**AGENDA
TECHNICAL REVIEW COMMITTEE
REGULAR MEETING
DECEMBER 19, 2024
10:00 AM
CITY HALL COMMISSION CHAMBERS
204 ASH STREET
FERNANDINA BEACH, FL 32034**

Project Type*	Project Name
Site Plan Review	WAFFLE HOUSE - AMELIA ISLAND, FL

The City of Fernandina Beach received your request for site plan review on Monday, November 18, 2024. A complete application was determined on Wednesday, November 22, 2024. All submitted documents provided were routed to the Technical Review Committee (TRC). The comments provided as part of this site plan review are valid for six months from the date of issuance.

Please let this letter, and the attached, serve as Waffle House's response to your plan review comments completed 12/04/24 for the above-referenced project.

SITE PLAN

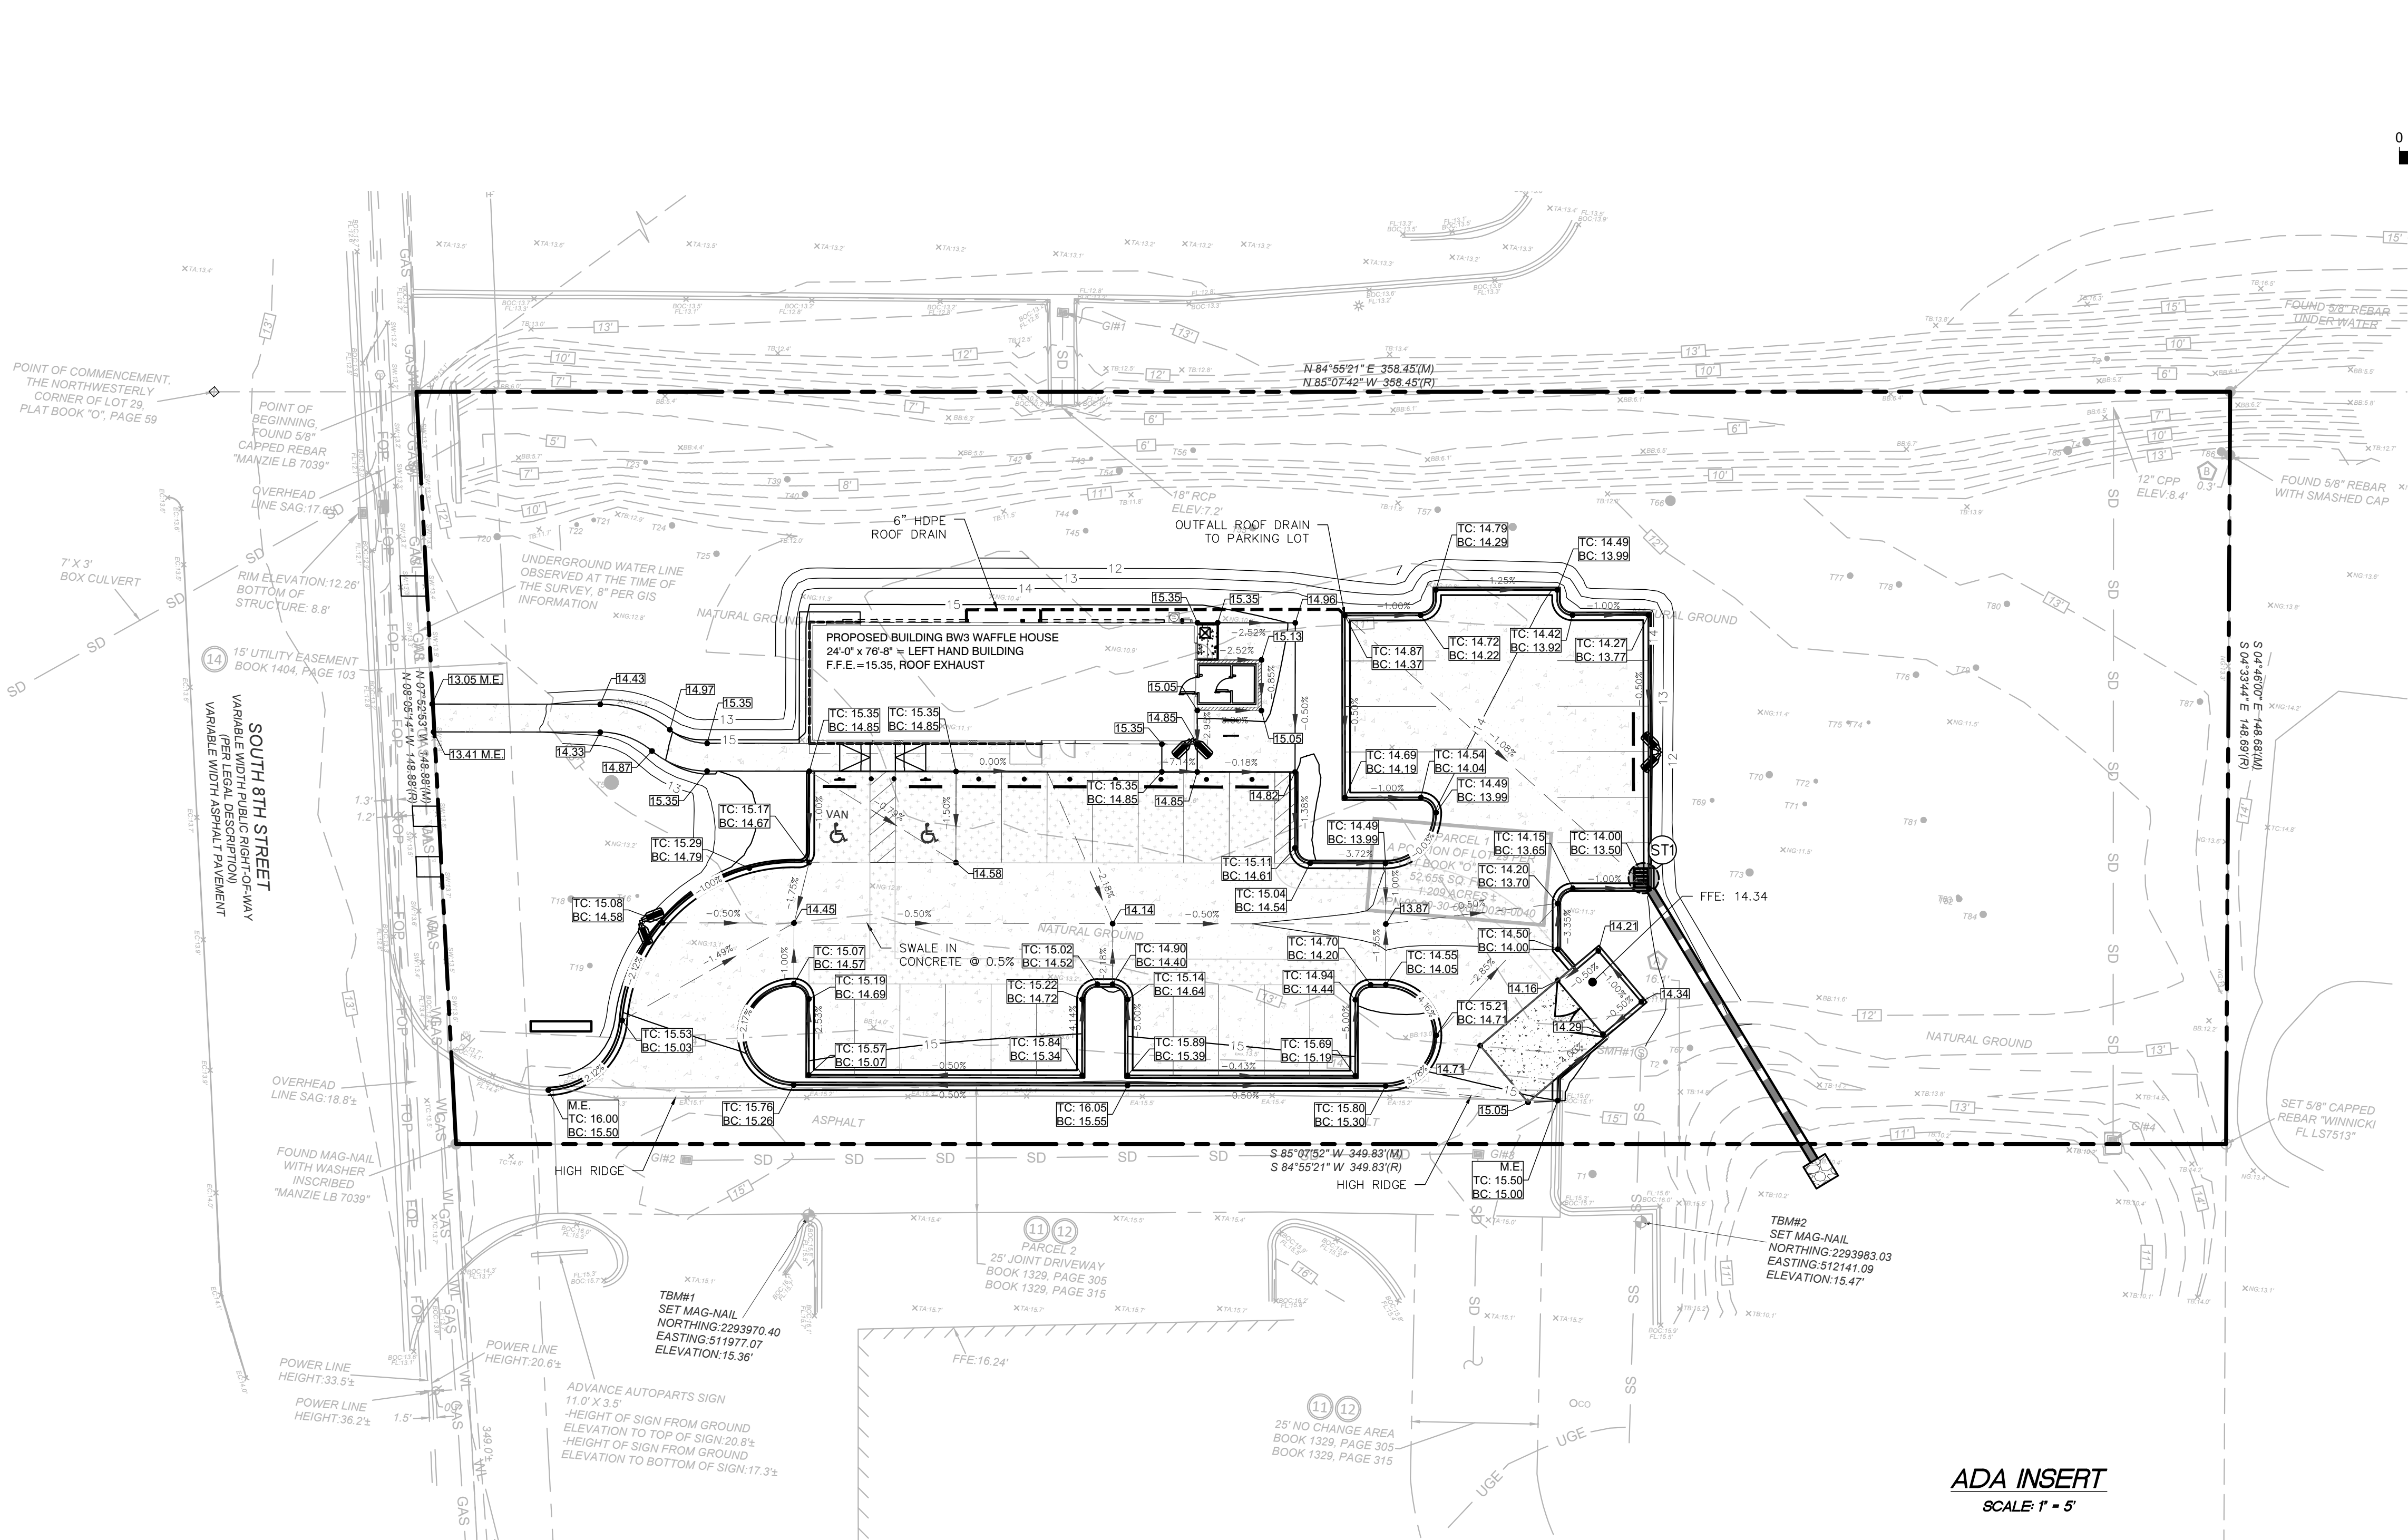
1. Per page 10, tree removal table shows 39 trees removed at 468 inches and retaining 47 trees at 654 inches. No mitigation required.
Response: Noted.
2. Per LDC 7.01.04 Parking Standards and Parking Lot Design: At least twenty (20) percent of new parking areas and drive aisles must incorporate alternate paving materials such as: decorative pavers, bricks, scored concrete, or paving patterns. - Suggestion: Please consider incorporating this requirement by creating clear pedestrian walking paths from the parking lot to the entry and from the rear employee exit to the dumpster location as this would provide an additional safety feature for guests and employees.

Response: Addressed. Stamped concrete has been added. Please see sheet C02 plan view as well as the Site Summary table for more information.
3. Lighting Plan: It appears that there is a very low level of lighting at the approach to the dumpster location. Employees may feel more comfortable and safer if additional lighting was provided nearer to the entry to the dumpster. Landscape lighting or a security light at the dumpster may be an option.

Response: Waffle House elects to leave the light locations as shown per Waffle House standards.
4. Per LDC 4.02.00 DESIGN STANDARDS FOR BASE ZONING DISTRICTS; Table 4.02.01(J). Design Standards for Lots; Please show the calculations to demonstrate that the project meets the 60% Impervious Surface Ratio. Include all impervious surface areas. It does appear to satisfy the requirement, but we would like to see the calculation included.

Response: Addressed. Please see sheet C02, Site Summary table.

5. Per LDC section below, please show the required bicycle spaces. The number of bicycle spaces required is as follows: Table 7.01.03(E). Required bicycle spaces for specified uses. Commercial uses 1 space per 25 required vehicle parking spaces, Bicycle parking spaces may be provided as either bicycle racks or other storage facilities, provided that the following standards are met:
- Facilities shall be designed to allow each bicycle to be secured against theft;
 - Facilities shall be installed to resist removal;
 - Facilities shall be installed to resist damage by rust, corrosion, or vandalism;
 - Facilities shall accommodate a range of bicycle shapes and sizes and allow easy locking without interfering with adjacent bicycles;
 - Facilities shall be located not to interfere with pedestrian or vehicular movement.

Response: Addressed. Two bicycle spaces have been provided at the rear of the building and the calculations have been added to the Site Summary table. Please see sheet C02.

UTILITY PLAN

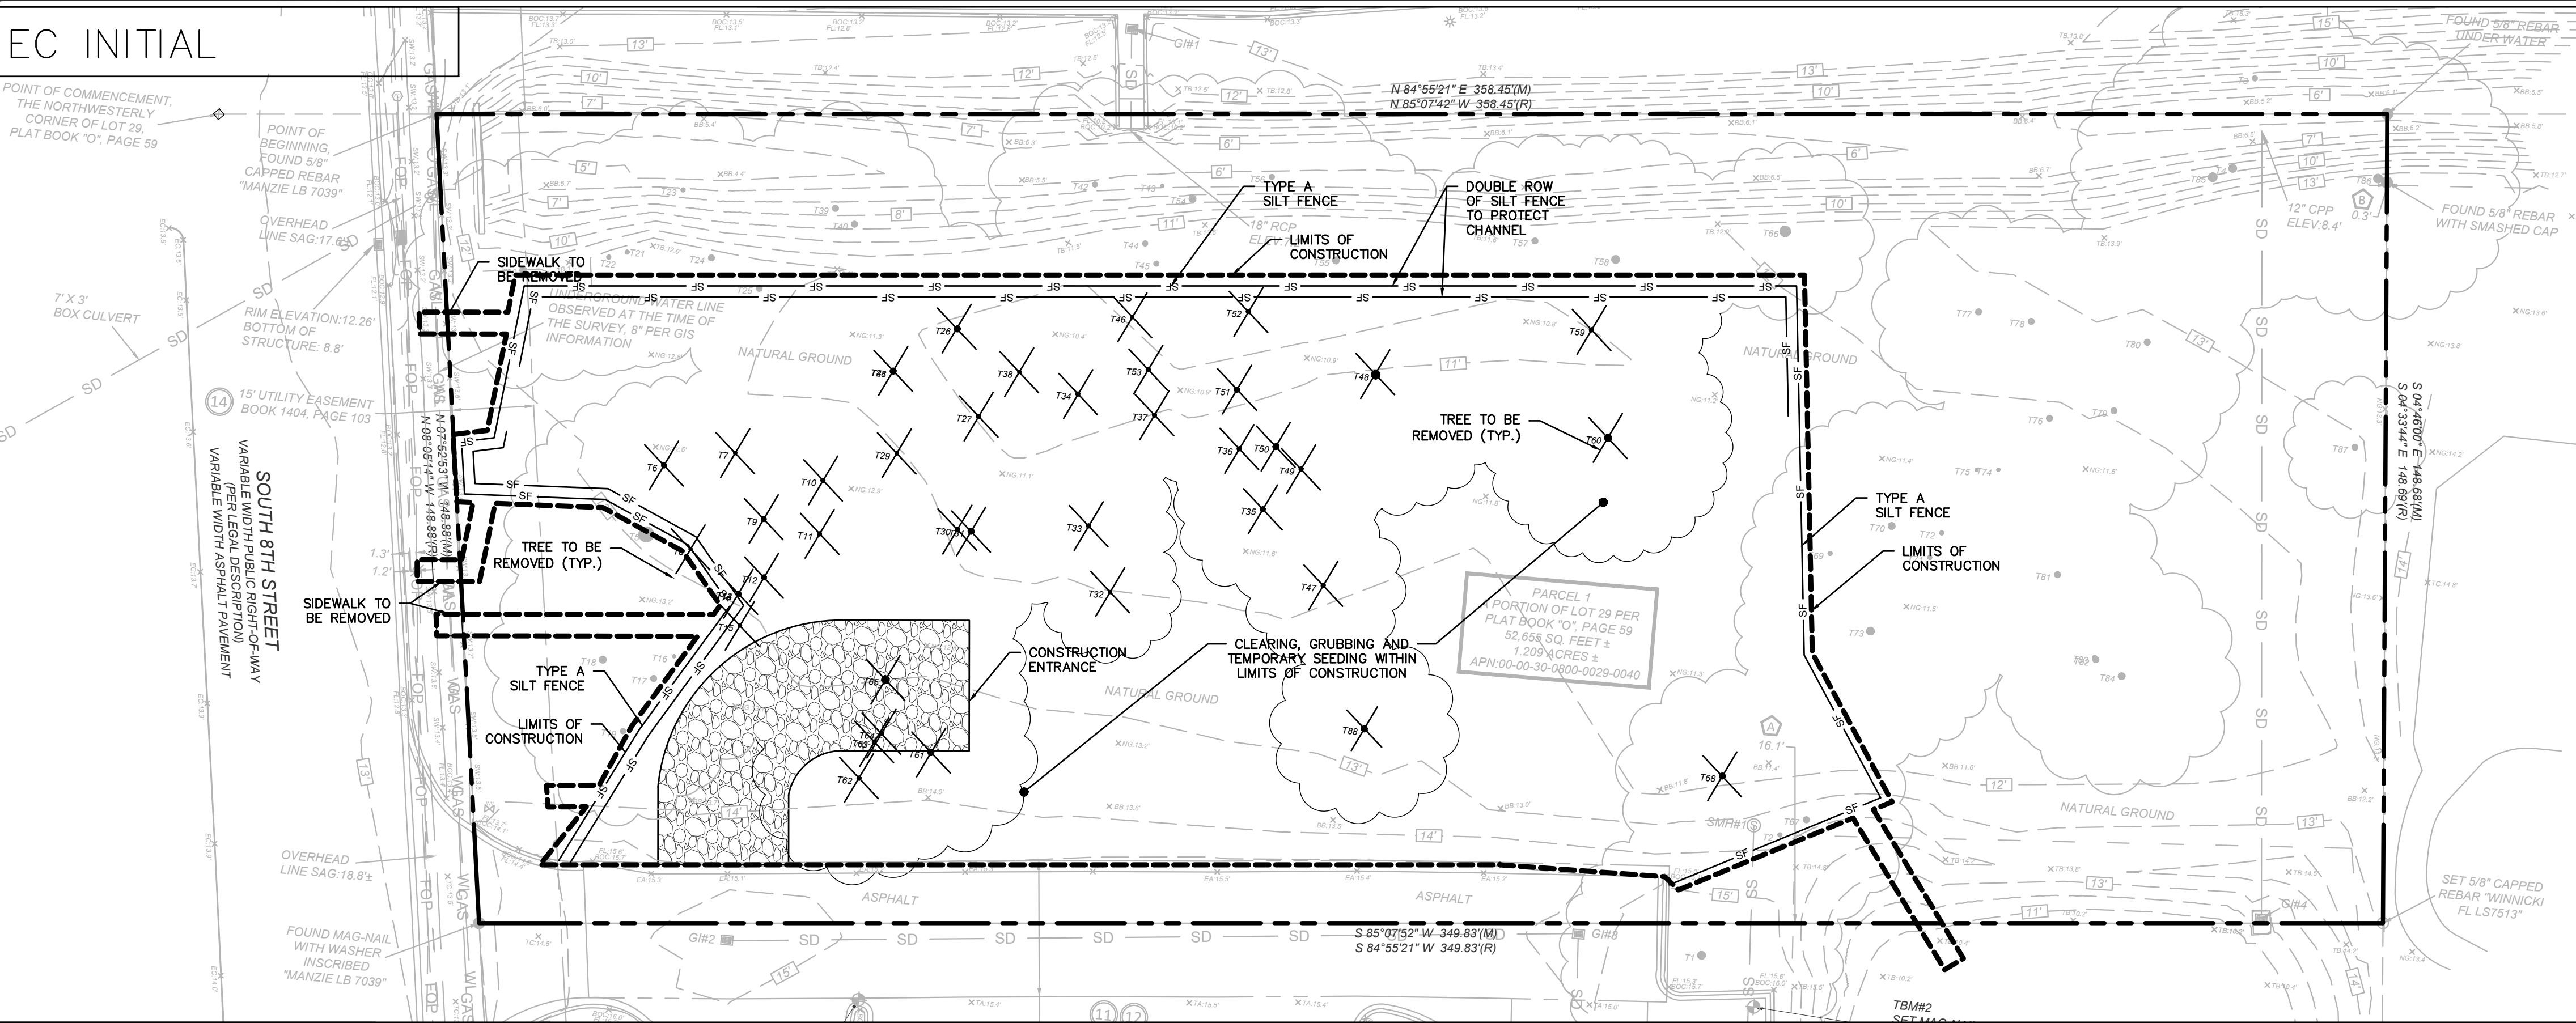
- Ductile iron is not allowed in the City.
- For pipes of different sizes, match the crowns of the pipe, not invert.
- Please provide details on the manhole.

Response: Addressed. Please see sheet C04.
